HAMMOND ORGAN

May 3, 1965

SUBJECT: * IMPROVED REVERBERATION RESTRAINT BRACKET

19 L-100 Series
M-100 Series
S-100 Series

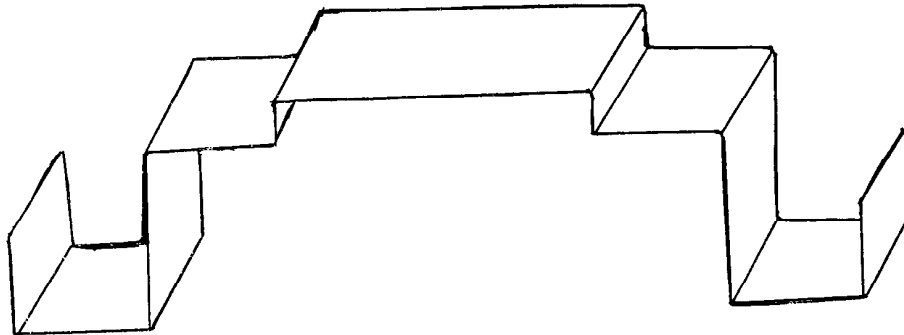
An improved method for immobilizing the reverberation unit has been devised to replace the present corrugated inserts, and will be on all units mentioned above in the near future.

It will be a formed metal bracket, and will be locked in place by bending the two end tabs over the outer edges of the "R" unit body.

This bracket can, and should be re-used whenever the organ is to be moved any appreciable distance.
